Access Compliance Report

Public Rights-of-Way

(Curb Ramps)

Intersection ID: N/A	Main Street: KIMMERLY_GLEN_LN	Cross Street: ENDOLWOOD_DR	Location: NW
ADA ID: A9596EB09B67	Ramp Type: Directional1	Initial Pass/Fail: Fail	Overall Compliance: No
		Severity Score: 25

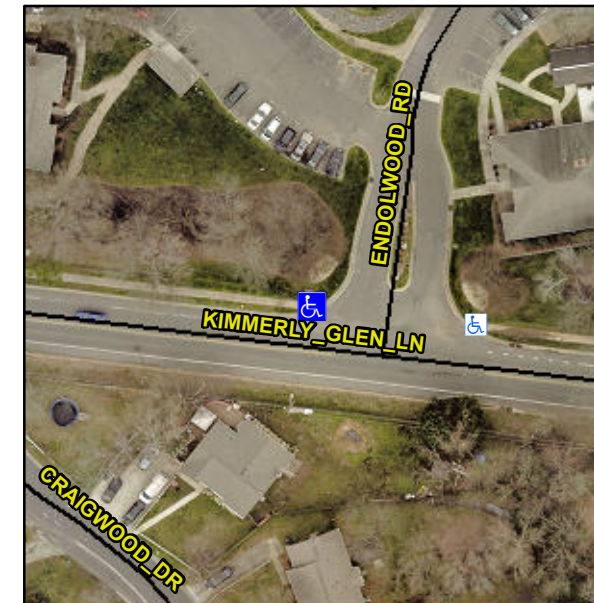
R304.2.2, R304.5.3

Compliance	Description	Data	Compliance	Description	Data
N/A	Ramp Length (in)	48.0	N/A	Grade Break?	N/A
Yes	Ramp Width (in)	48.0	N/A	Grade Break Slope (%)	0.0
No	Ramp Slope (%)	10.9	N/A	Grade Break XSlope (%)	0.0
No	Ramp XSlope (%)	6.4			
N/A	Flare Type LT	N/A	N/A	Flare Type RT	N/A
N/A	Flare Slope LT (%)	N/A	N/A	Flare Slope RT (%)	0.0
N/A	Flare Traversable LT?	N/A	N/A	Flare Traversable RT?	N/A
N/A	Landing Length (in)	0.0	N/A	DWS Provided?	N/A
N/A	Landing Width (in)	0.0	N/A	DWS Contrast?	N/A
N/A	Landing Slope (%)	0.0	N/A	DWS Length (in)	N/A
N/A	Landing X Slope (%)	0.0	N/A	DWS Full Width?	N/A
N/A	Landing Curb? (Y/N)	N/A	N/A	DWS Offset LT (in)	N/A
N/A	Shared Landing?	N/A	N/A	DWS Offset RT (in)	N/A
N/A	Gutter Ponding?	0.0	N/A	Gutter Slope (%)	N/A
N/A	Gutter Lip Ht (in)	0.0	N/A	Gutter X Slope (%)	N/A
N/A	Painted X Walk1?	No		Road Slope (%)	2.7
	X Walk 1 Direction	To E		Road X Slope (%)	2.2
	X Walk 1 Width (in)	N/A		Clear Space?	N/A

Remove & Replace Entire Ramp.
